Parcel 34 Pebb Capital Final Plan Review

I-195 Redevelopment District Commission Meeting
February 26, 2024

Overview of Changes: Bassett St View

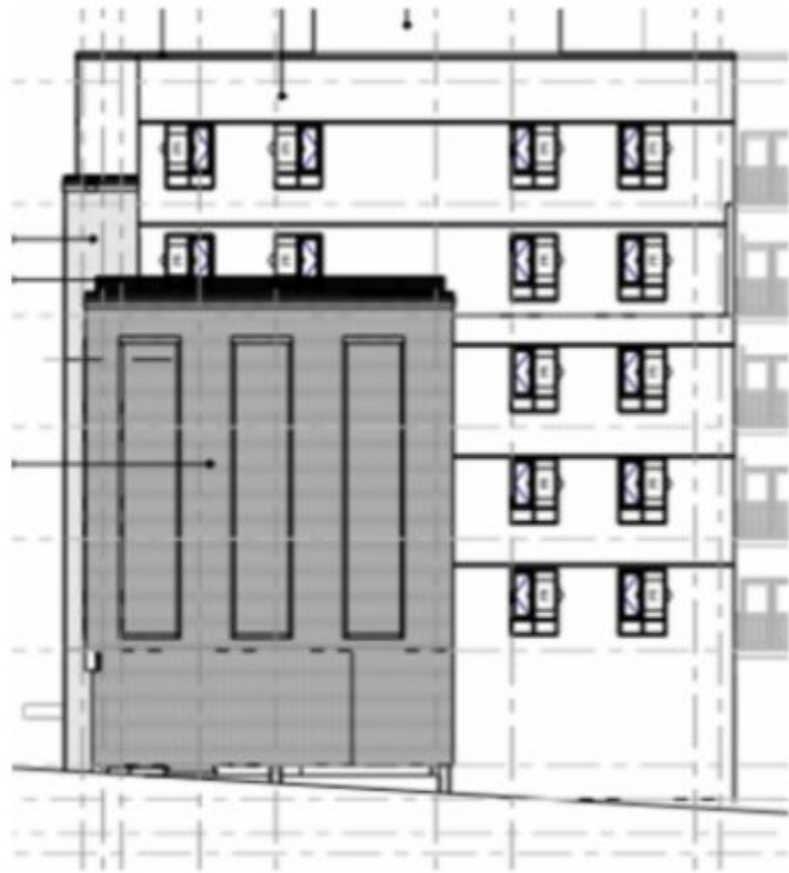
- 1. DDRC Final Plan Approval - **secured on Feb 12, 2024**
- 2. Impacts of Zero Lot Line Development
 - a. Clarify zero-lot-line facade design intent. Openings at the zero lot line abutting Parcel 34 were depicted in the render titled “South West Facade from Bassett Street”
- 3. Retaining Wall Treatment
 - a. Clarify treatment of retaining wall and guardrails next to below-grade parking garage entrance
- 4. Building Facade Color Palette
 - a. Clarify urban design logic around proposed color palette of building facades

Windows at zero lot line removed and replaced with framed panels in brick

Retaining wall and guardrail conditions clarified
